CITY PLANNING COMMISSION

- APPLICATION:
- A. Variance to locate a portion of parking maneuvering space off-site.
 - B. Lot Line Adjustment.

PROPOSAL: The applicant is requesting the necessary entitlements to develop a 42 unit apartment complex known as Riverview Villa II on 1.8± vacant acres.

EXHIBIT A

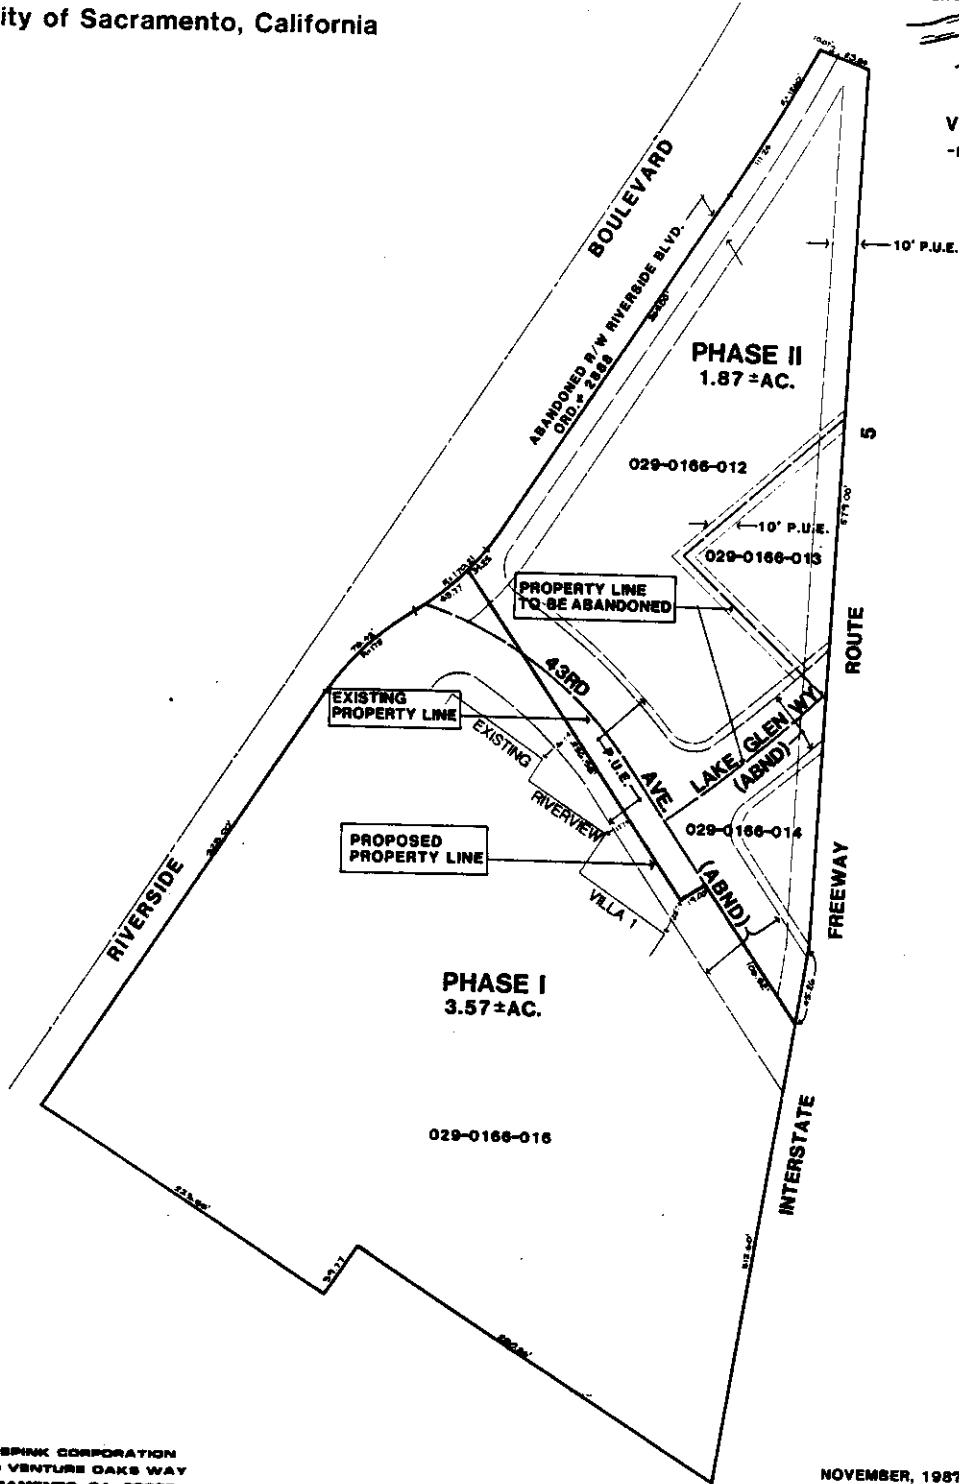
4. The existing entry into parking area shall be modified as a private driveway entry.
5. The applicant shall develop additional parking on Riverview Villa I apartment complex site as shown on Exhibit A to satisfy 1.5:1 parking requirement. Detached site plan indicating carport structure and landscape treatment for this parking lot expansion shall be submitted to Planning Director for approval prior to issuance of building permit.

SITE PLAN

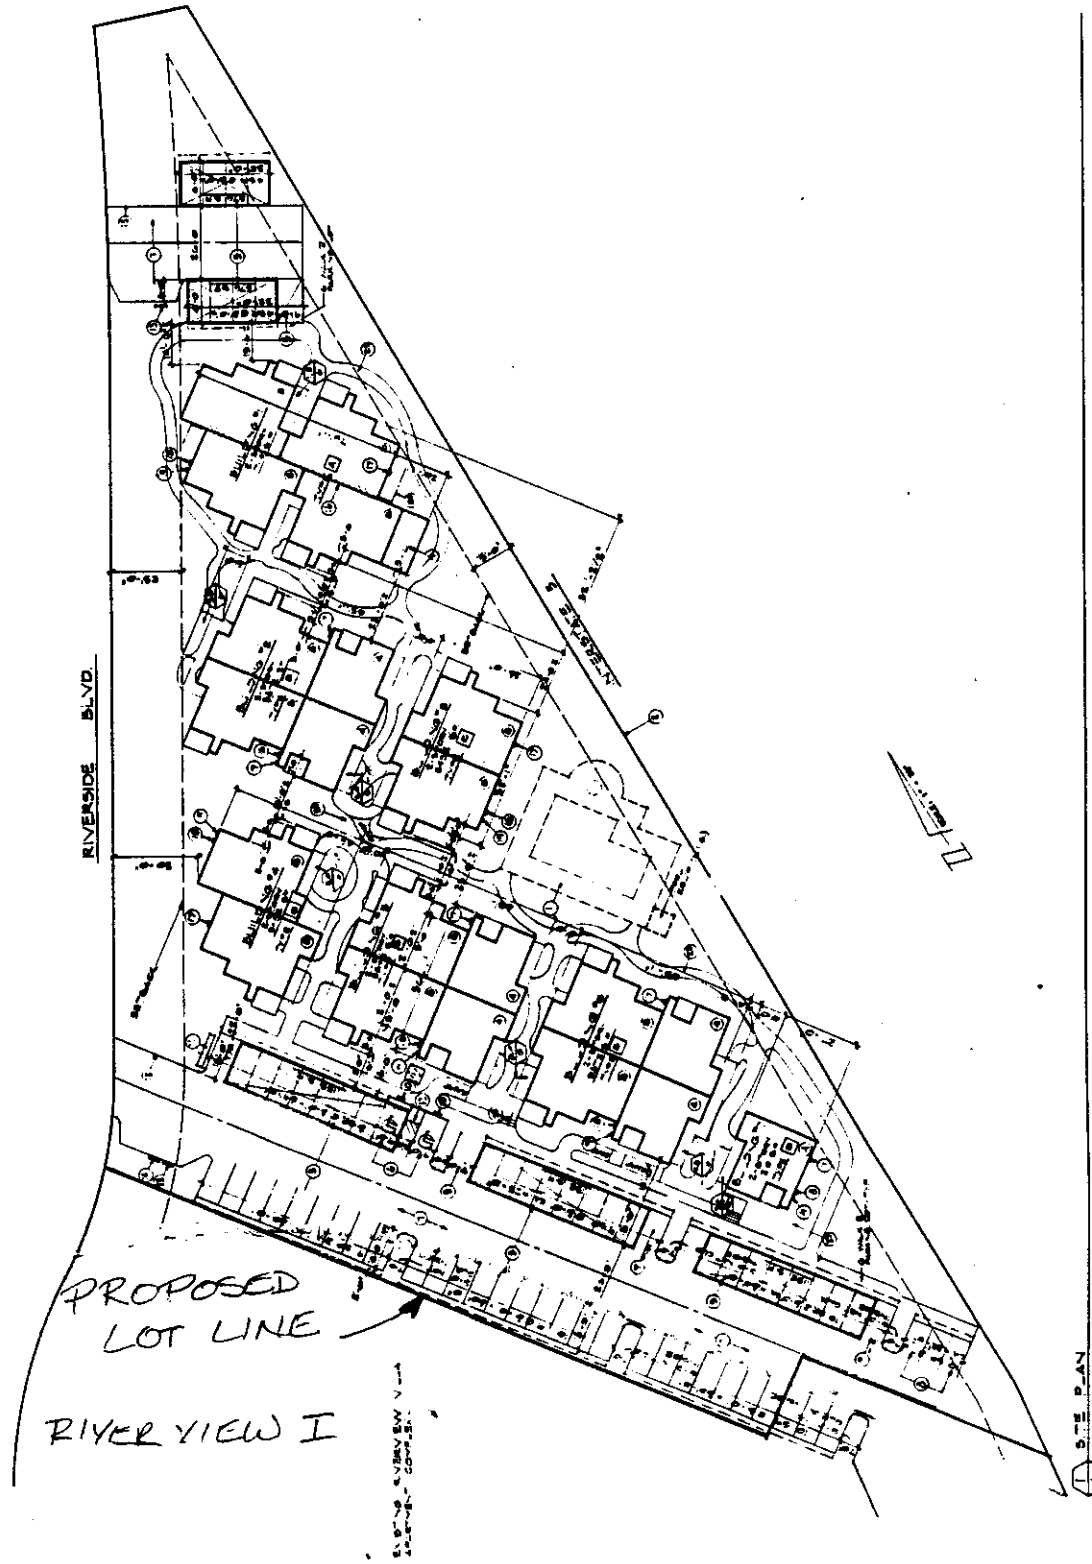
- 1. The applicant shall record the necessary cross access and maneuvering agreements prior to issuance of building permits.
- 2. The parking on the old road right-of-way shall be striped with 90 degree parking spaces per the attached site plan.
- 3. Applicant shall comply with conditions of P85-213.
